**HDC-2022-00045**

**Address: 814 W. Liberty Street**

**Proposal: Remove infill at window and install shutters (Violation Correction)**

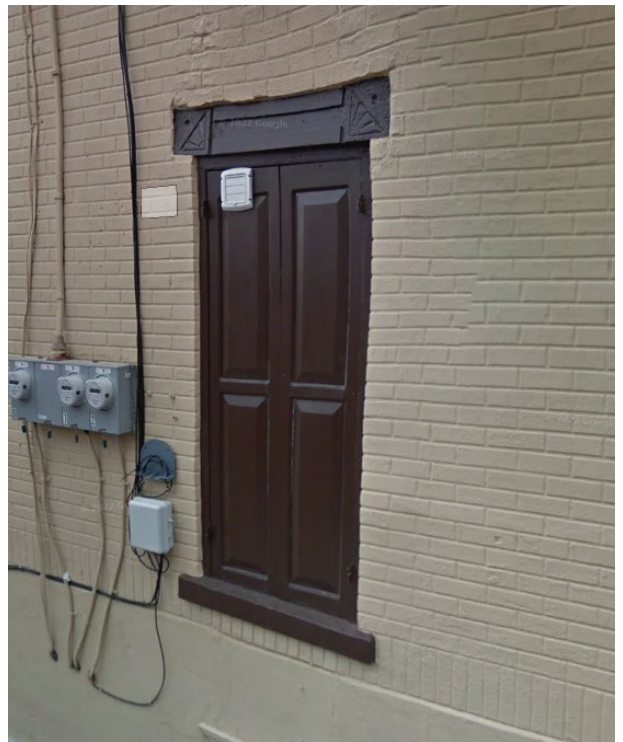
The HARB reviewed and approved the sealing of the window and installation of the paneled shutters in 1994. The paneled shutters were permanently closed on the exterior to offer the appearance of the original opening, though the opening no longer retained its historic function. Staff finds the application to be appropriate in the reversal of the infill and

sealing of the opening with shutters and requests that the dimensions of the masonry opening, masonry reveal, lintel, sill, and window frame are retained or reinstalled. The application lacks sufficient detail to confirm whether the window will be returned to its previous condition. A more detailed elevation and section drawing showing the dimensions of the opening, reveal, lintel, sill, and frame should be submitted. Returning the masonry opening, even with a sealed window, will maintain the pattern of historic window openings and will comply with the Guidelines.

The use of salvaged wood shutters is appropriate according to the Guidelines. The proposed louvered shutters are a close match to the existing louvered shutters at the primary facade and are an appropriate material. The paneled louvers were installed in 1994 and are therefore not considered a historic feature that needs to be replicated (COA 1994-50, Resolution 26967). These were approved to be installed in a fixed closed position. Photographs from 1994 indicate that the window was already obscured.

- the infill is carefully removed so as not to damage the historic masonry or lintel;
- the shutters are installed on a wood frame to match the historic window frame and fit the full height and width of the opening;
- the shutters are installed within the original opening so that a masonry reveal of approximately 1.5 to 2-inches is maintained;
- a wood sill to match the historic is installed; and
- the coating is carefully removed from the lintel or painted to match the trim.
